Council Ref: #779975
Our Ref 71631

Information Response
MCU Multi-Unit Housing & Holiday Accommodation
33 Davidson St, Port Douglas

**RESPONSE TO ITEM 1 OF INFORMATION REQUEST #779975
MCU MULTI-UNTI HOUSING AND HOLIDAY ACCOMMODATION
33 DAVIDSON ST, PORT DOUGLAS**

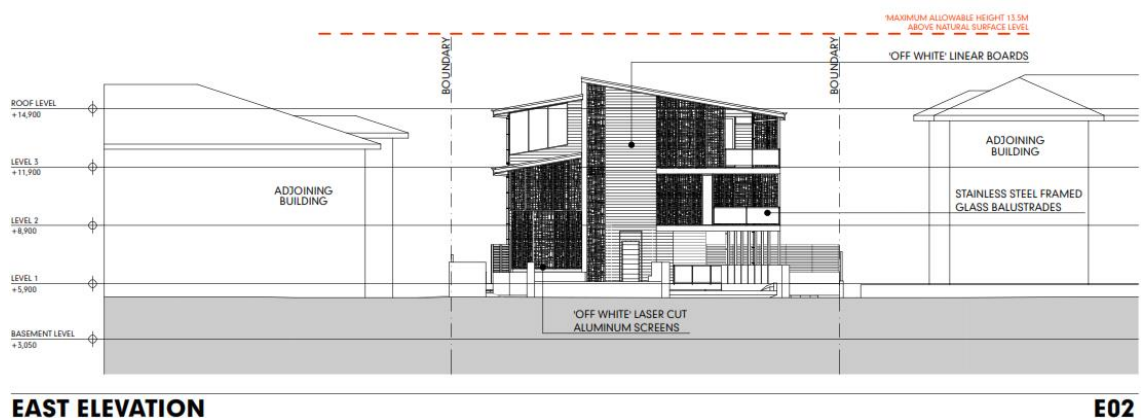
3. **Demonstrate how on-street works relate to significant trees and existing landscaping within the road reserve.** The access has been re-designed by Flanagan Consulting Group engineers to include a split driveway, that retains the trees see attached plan 4694 SK01.
4. **Demonstrate how the proposed access will address the bus stop area / location of new bus stop.** The “existing bus zone” consists of a faded sign, which is proposed to be moved 3m to the north – in line with the common boundary with the adjoining property. It is standard practice to put infrastructure on the boundary rather than in the front of a property, it is likely that because the site was vacant, no detailed thought was given to the original location.

There is no change to the width of the road reserve or the location of the existing bus zone. The bus zone as shown below is still a minimum of 9.5m in length with additional room for pulling in and pulling out. Refer to attached Drawing DANBRY001 A.3 REV A. There is sufficient capacity in the road reserve for the bus stop in its current location. It is only the sign that needs to be relocated.

4694-SK01 1:100
A1 Full Size

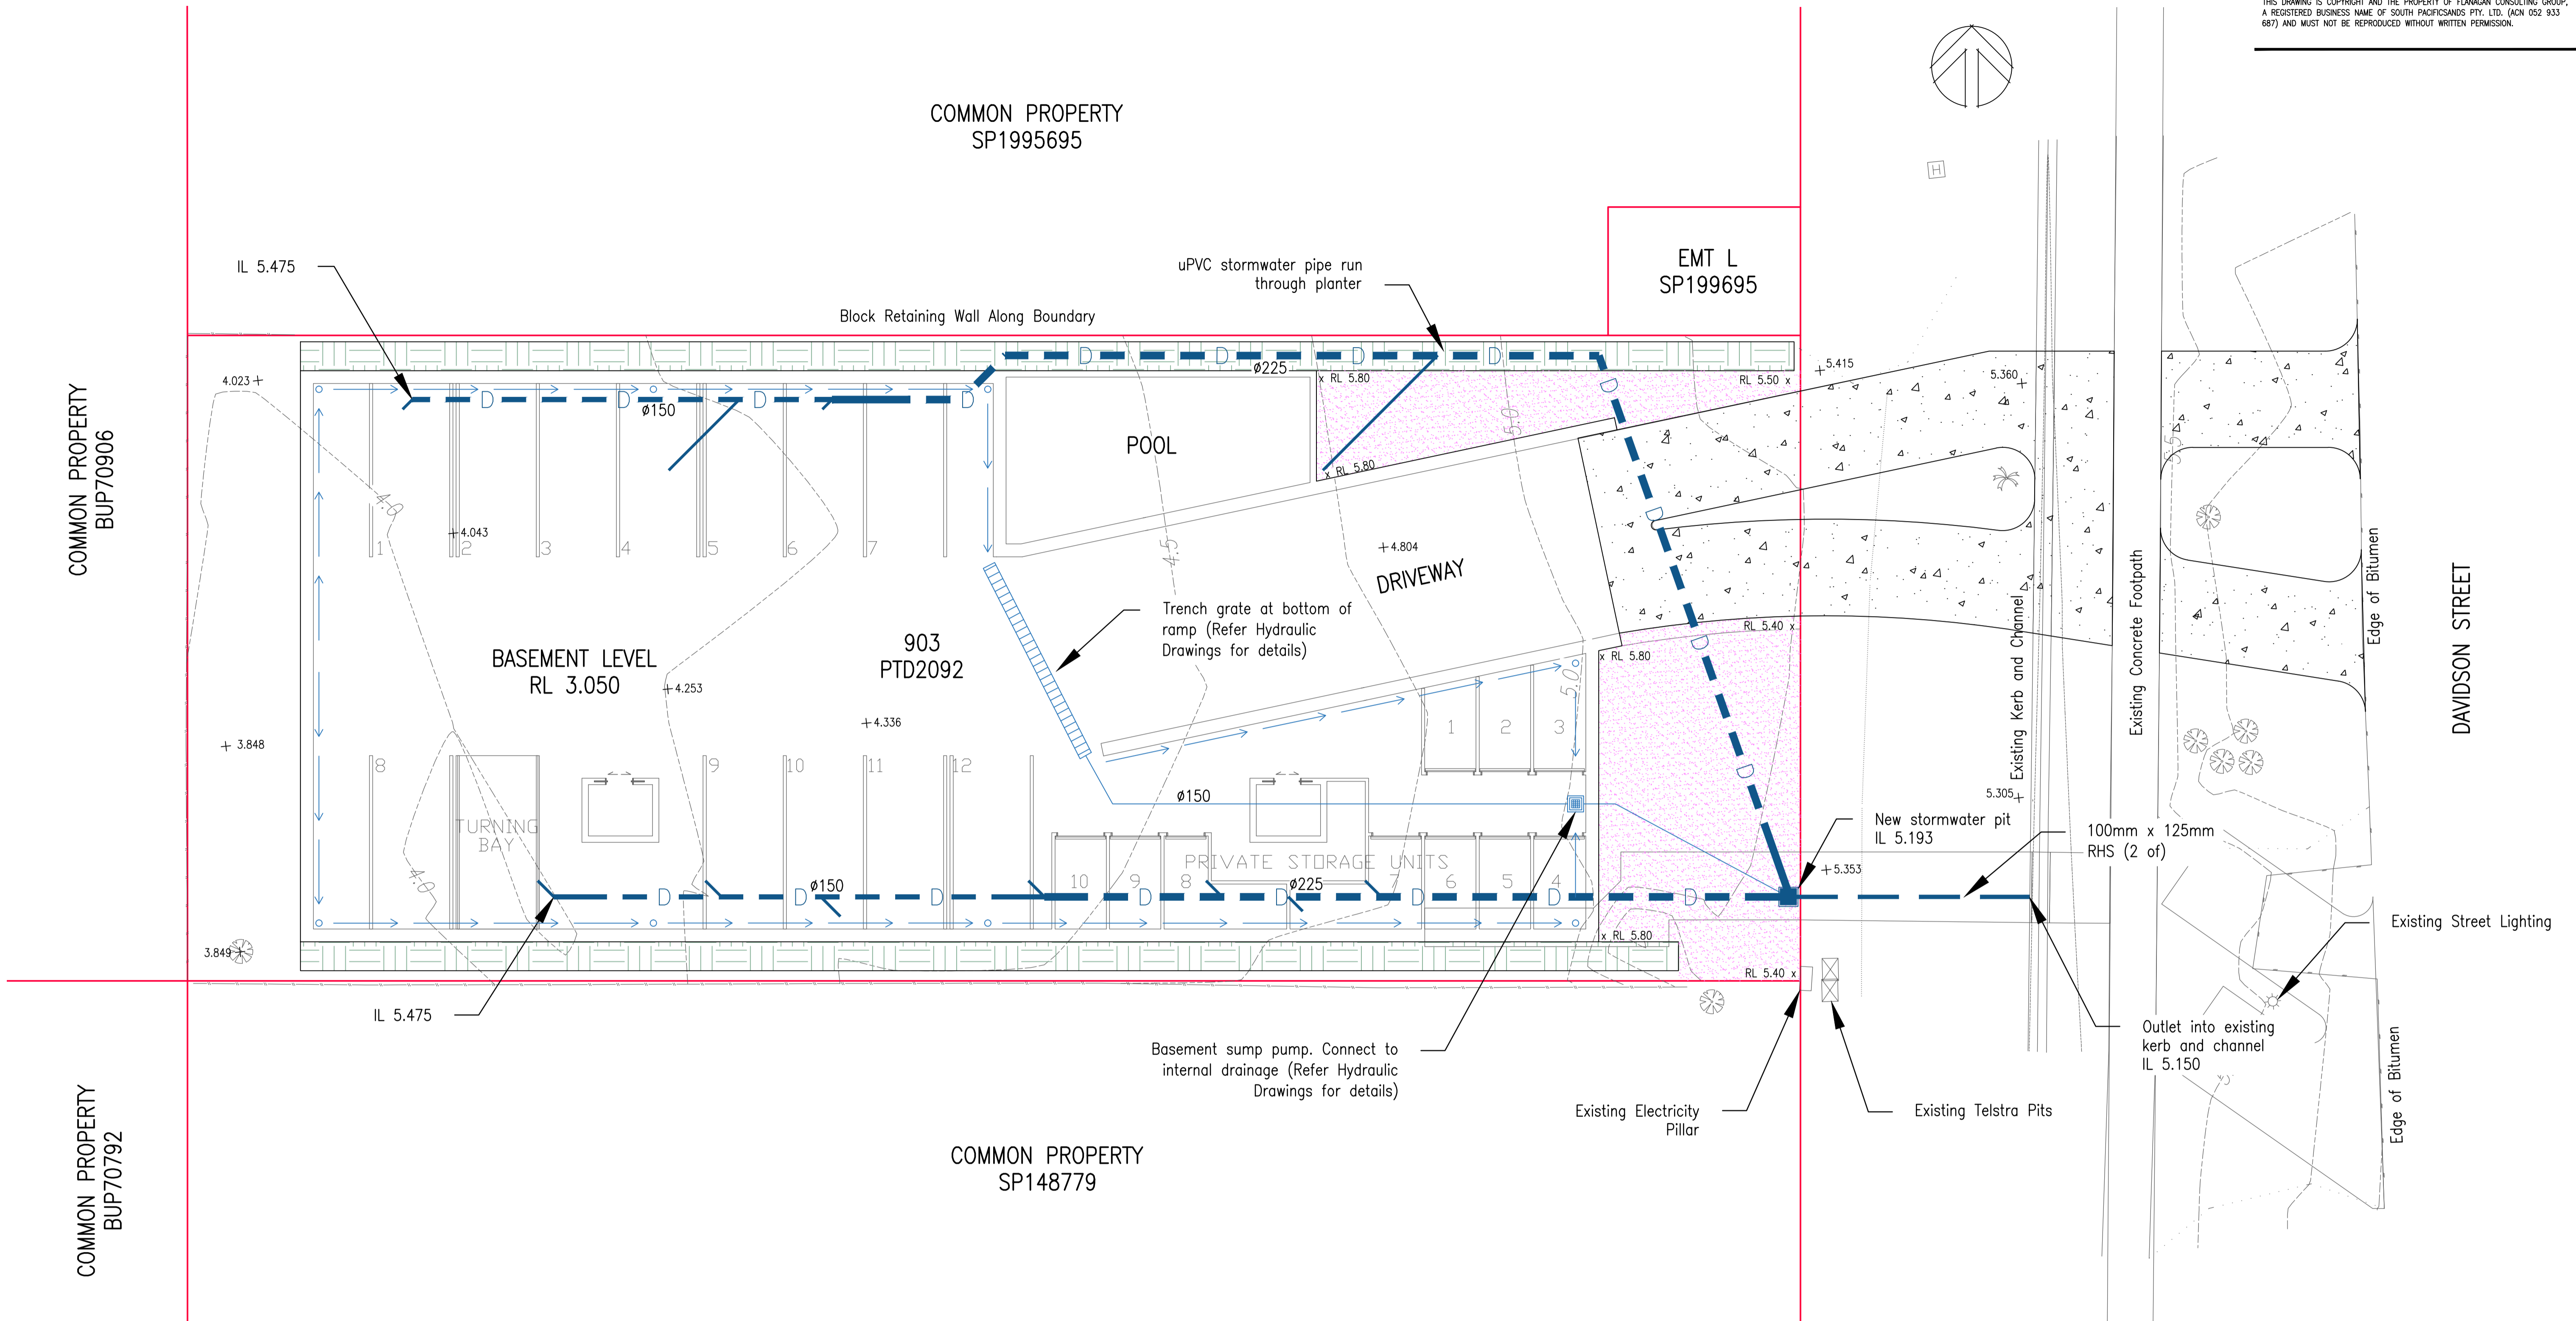
- demonstrate how storm water flows will be managed at the basement car park level;

- a Drainage Plan, detailing a lawful point of discharge, prepared by suitably qualified persons should be submitted as part of the response to the above; and

- provide basement level plans which demonstrate where all relevant services are to be located, this should also indicate how the storm water services (pumps etc.) can be accommodated within the development.

Roof water drainage will be connected to the basement soffit and piped to Davidson Street kerb and channel. Storm water entering the basement will be very minimal. This will enter the basement from cars driving into the basement during rain events and water seepage through the basement wall. These flows are very minimal and standard basement construction techniques of perimeter spoon drains and a small sump pump will collect the flow and pump it to the roof water pit located near the front boundary. Refer attached sketch plan 4964 SK01.

Please find attached our site concept drainage plan 4694 SK01 showing the kerb and channel as our legal point of discharge for piped drainage. This is similar to other developments in Davidson Street.

Please find attached our site concept drainage plan 4694 SK01 showing drainage services in the basement. Please note our plan is indicative and subject to future coordination with the hydraulic consultant.
